**Town of Kittery
 Planning Board Meeting
 July 11, 2019**

ITEM 3 – 76 Dennett Road – Mixed-Use Residential Development – Site Preliminary Plan Review
Action: Accept or deny application. Schedule public hearing. Owners William J. Cullen and Sail Away, LLC and applicant William Wharff request consideration of a mixed-use residential development on 23.3+- acres of land at 76 Dennett Road (Tax Map 6 Lots 15B & 16A and Tax Map 13, Lot 4) in the Mixed Use - Neighborhood (MU-N) Zone. Agent is Shawn Tobey, P.E. Hoyle, Tanner Associates, Inc.

Meeting Date: July 2, 2019
From: David Rich, Public Works Commissioner
Jessa Kellogg, Shoreland Resource Officer/Stormwater Coordinator
Subject: Review of Preliminary Plan for 76 Dennett Road

**RE: Town of Kittery, Planning Board Services
Mixed-Use Development Proposal – 76 Dennett Road
Lots 6-15B, 6-16A, 13-4
Preliminary Plan Approval Application
CMA #591.125**

OVERALL SITE PLAN
C5
 PROJECT NO. 569200
 SHEET 5 OF 25

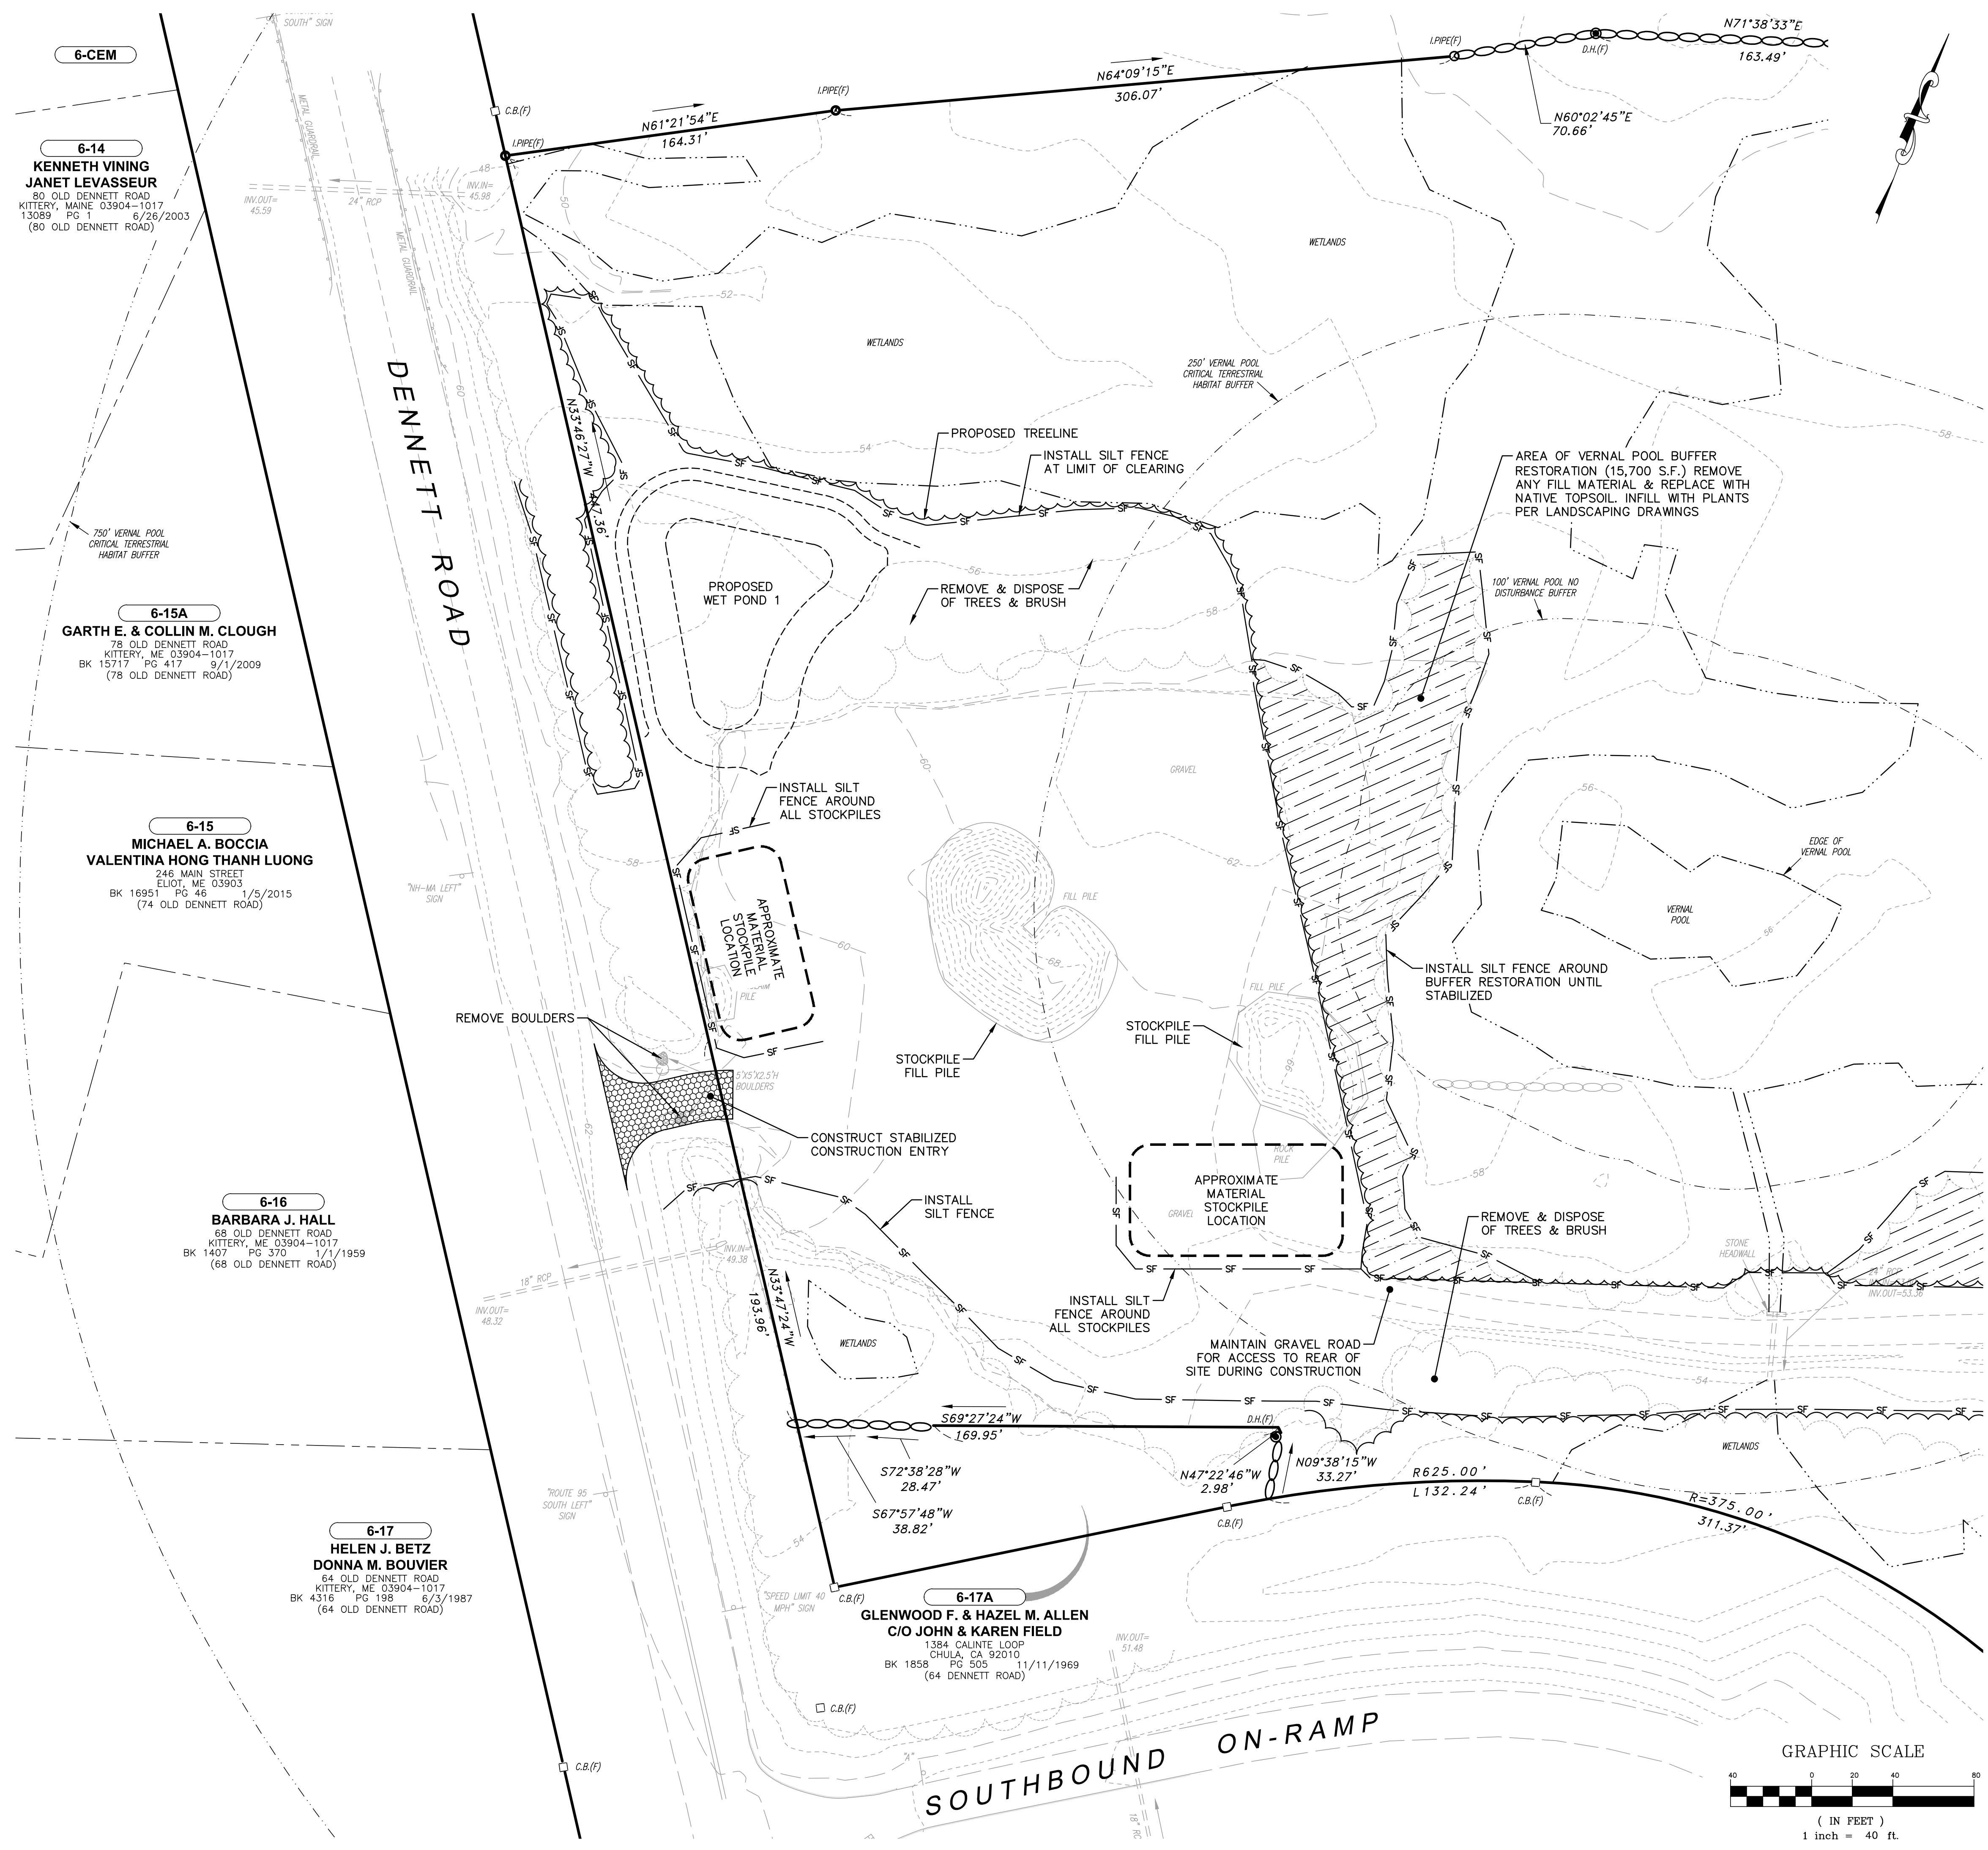
3. Parking calculations are listed on sheet C5 of the preliminary plans. The development will provide a total of 401 spaces:
 - a. Front Building = 114 spaces
 - b. Rear Buildings = 287 spaces

- Part of the parking for Building 1. Is in the front of the building, which requires review and confirmation and approval of the Planning Board.
- There are 401 proposed parking spaces (114 for Building 1. and 287 for Buildings 2. and 3.) This number exceeds the calculated requirements for parking by the various residential and commercial uses.
